11 January 2013

Verification of the Wetland Delineation and required Buffer Zones for the Kusile 10-year Ash Dam

Figure 1. Map showing the recommended buffer zone and the corner posts of the actual fence on site as verified on the 11 December 2012.

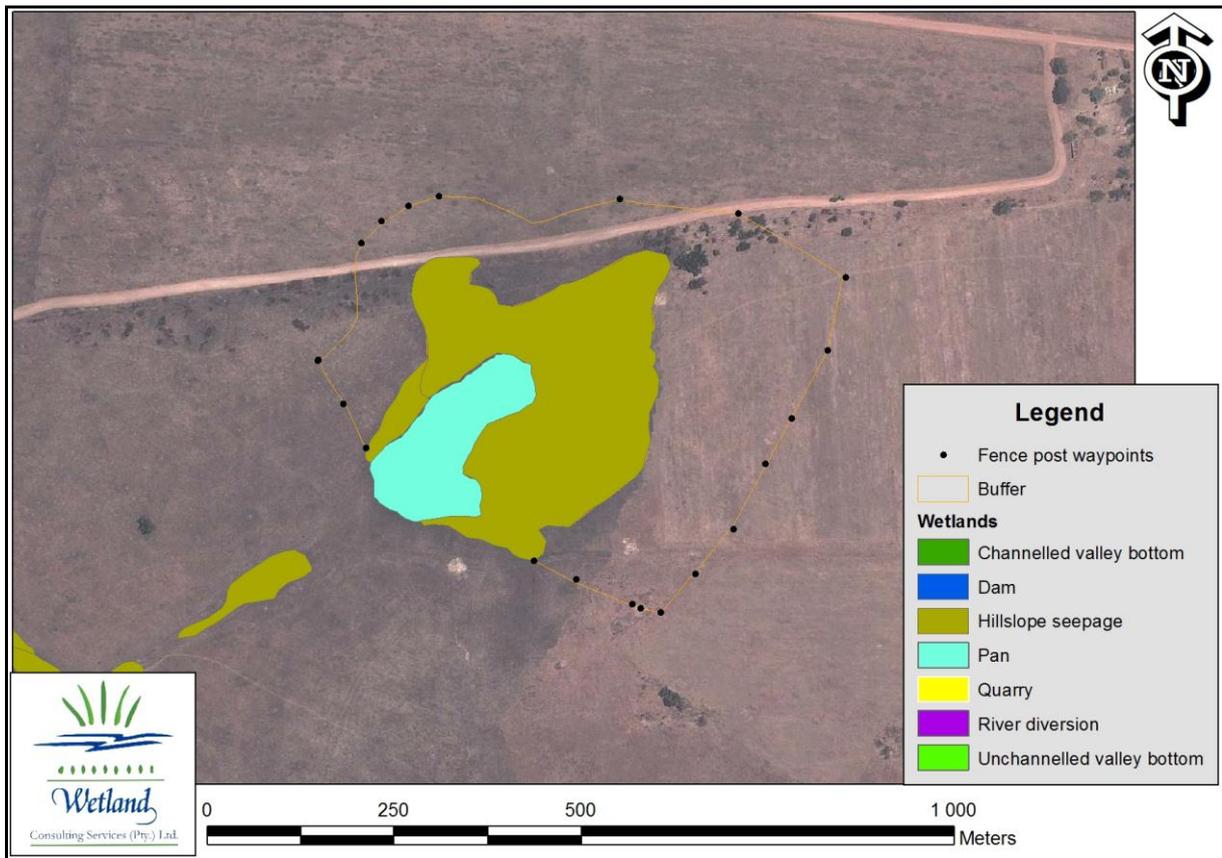
1. A site visit was undertaken on the 11 December 2012 and the 8 January 2013 during which the full length of the installed fence around the pan was walked and marked using a handheld GPS device. The marked waypoints were compared with the recommended buffer zone in GIS using ArcMap 10 (see Figure 1). The fence was found to accurately coincide with the recommended buffer zone.

Figure 2. Map showing the updated wetland delineation as well as the required 100m buffer zone along which additional fencing should be installed. The section of fence to be removed is also shown.

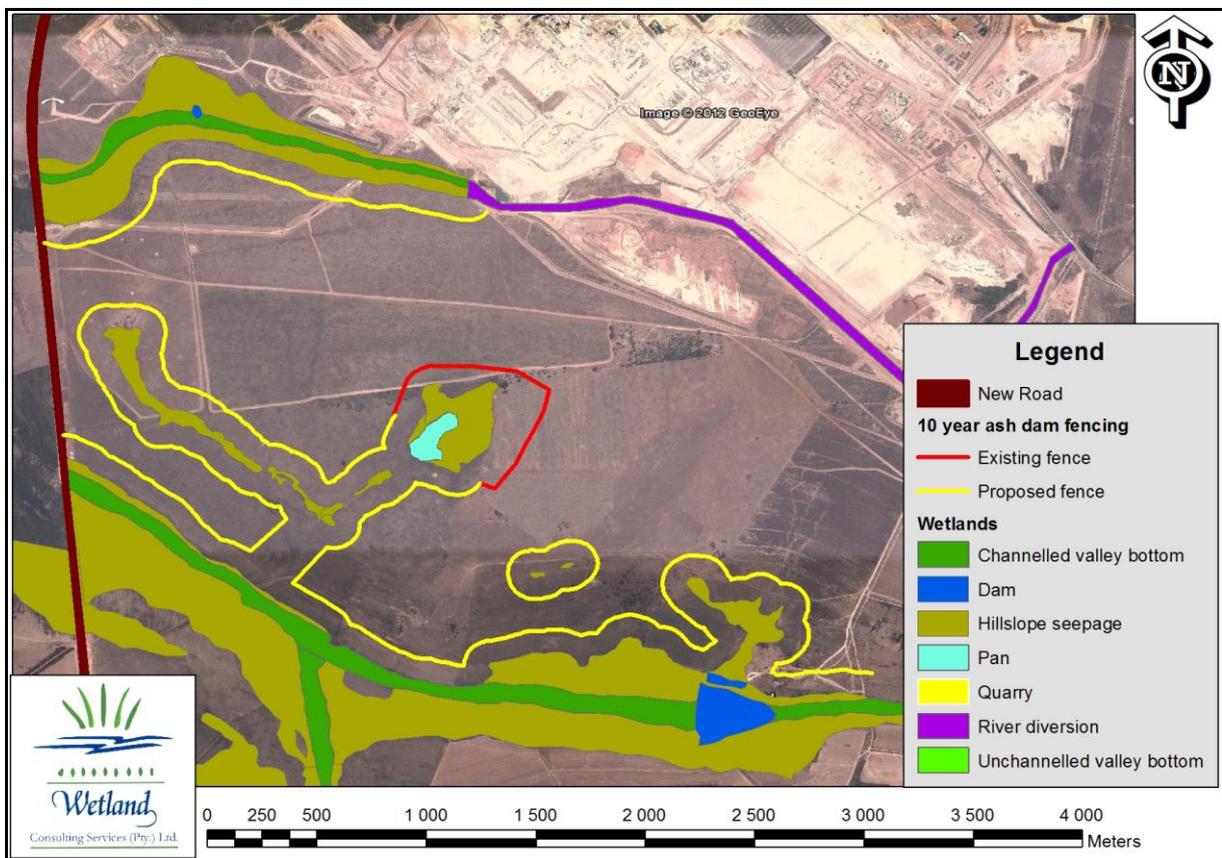
2. The wetland delineation was extended to all hillslope seepage wetlands adjacent to the proposed ash dam site and the boundaries verified. The eastern hillslope seepage wetland was found to be less extensive than initially indicated in the desktop delineation. However, a further two small contact seeps were identified and delineated, while the boundaries of the contact seeps immediately to the south west of the pan were also slightly adjusted. See Figure 2 above and the attached shapefiles. All of these wetlands should be fenced off as well. ***For the purpose of the fence, a 100m buffer zone is required as per the license conditions (Section 3.5.20; License No: 04/B20F/CGI/1836).***

3. Shapefiles and .dxf files of the delineated wetlands and the required 100m buffer zone are attached to this letter. It is recommended that the same procedure be followed as was implemented to install the fence along the pan buffer zone, as it is clear that the procedure worked. The attached shapefiles are as follows:
